**RIDGECREST SOLAR POWER PROJECT (09-AFC-9)
DATA ADEQUACY SUPPLEMENT**

Technical Area: Transmission System Design

Response Date: October 26, 2009

Following are additional information and/or clarifications in response to the specific issues raised in the CEC staff Data Adequacy review. For each specific area where the questions were raised by CEC staff, the applicable section of the CEC Siting Regulations is identified, followed by the "Information Required to Make AFC Conform with Regulations," followed by the supplemental/clarifying information.

**Figure 2-15
RSPP**

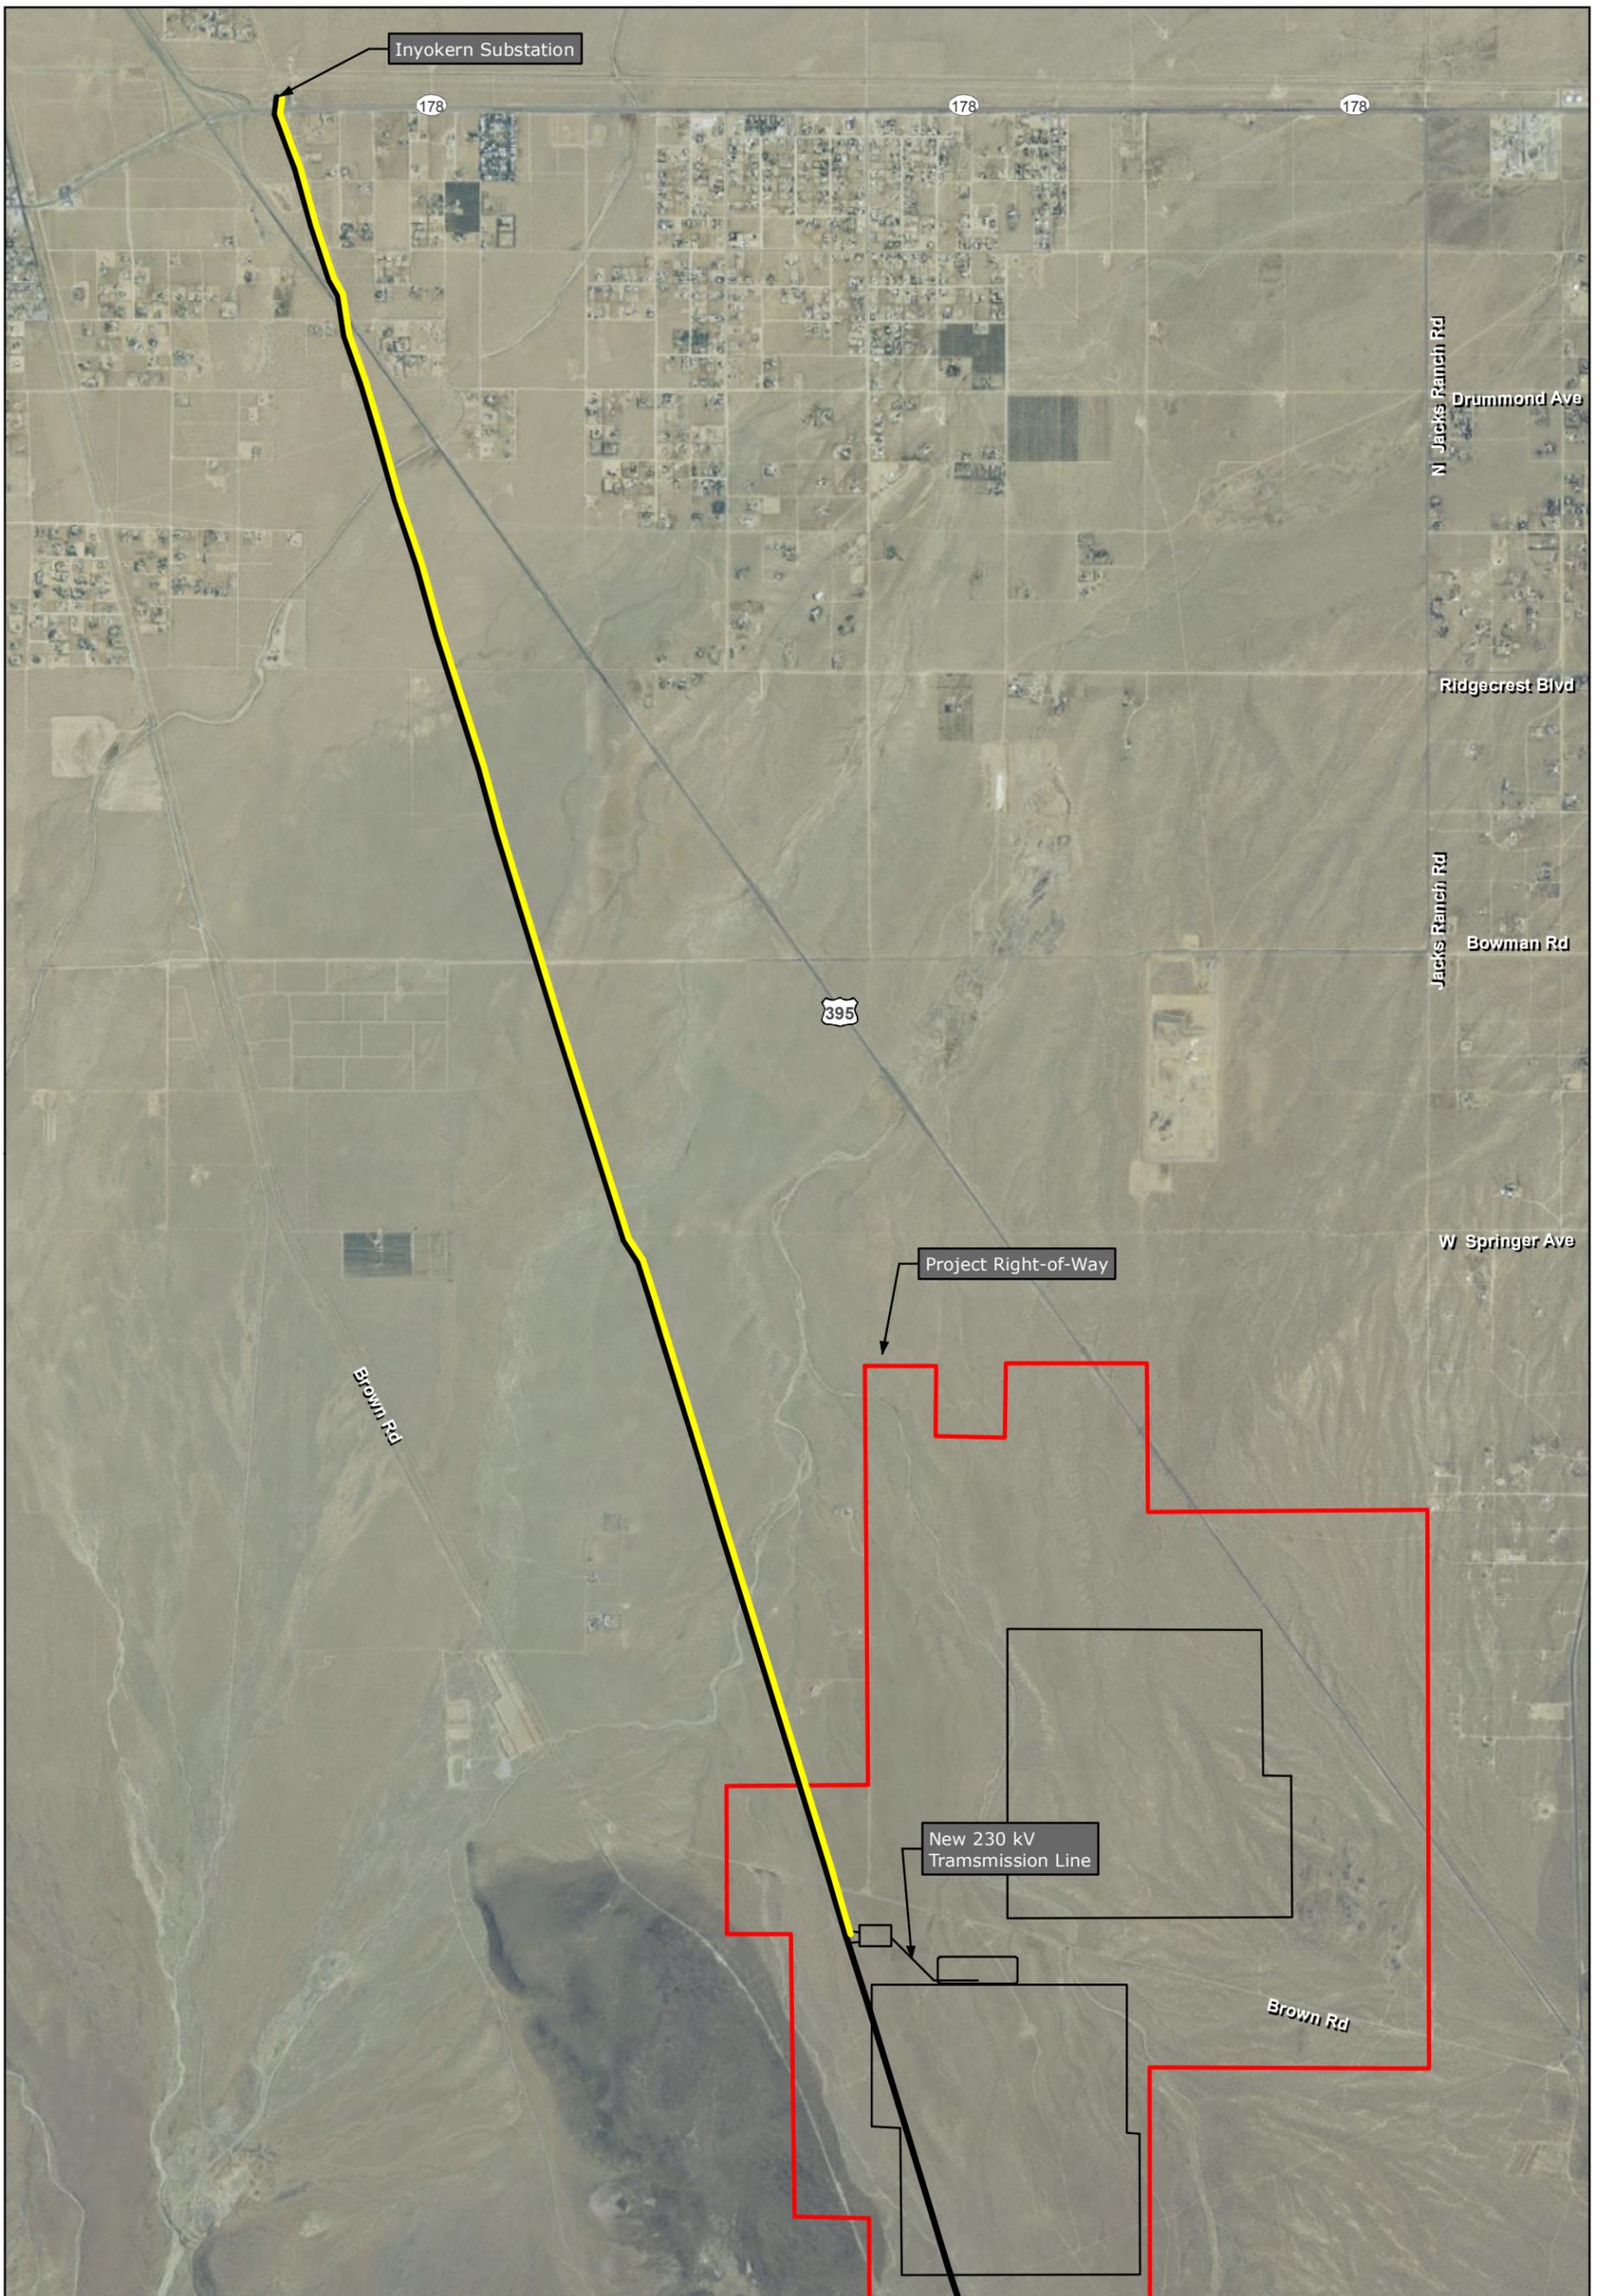
Submit a drawing showing the alternate routes of the proposed 230 kV generator tie lines and describe how the preferred route is selected by comparing to alternate routes and their environmental effects.

As described in Section 4.7 of Section 2.0 of the AFC, Project Description, an alternative that was explored was to interconnect at Inyokern Substation, which is located five miles northwest from the Project site. Please refer to Figure 2-15, provided at the end of this section, which depicts the alternative generator tie lines. This route, which was identified in the CAISO Phase I Study as the only “competitive” alternative, is rejected, because it would require the construction of five additional miles of new transmission line. Such a new line would have to be constructed either in the existing ROW for the SCE 230 kV line or a new ROW would have to be obtained. The existing ROW is occupied by a 115 kV transmission line in addition to the SCE 230 kV line. It is uncertain if this ROW could support an additional new 230 kV transmission line. Constructing a new 230 kV transmission outside of the existing ROW would be extraordinarily difficult if not infeasible since it likely would require obtaining the permission of dozens of private landowners.

The preferred route has the generator tie line connecting less than 0.1 mile from the existing SCE 230 kV to the new SCE Millennium Substation within the Project ROW. This route was selected because it was the shortest route and most suitable location to interconnect to the SCE 230 kV line while minimizing environmental impacts and costs. The route, identified as “viable” in the CAISO Phase I Study, causes the least disturbance to the site area and surrounding environment.
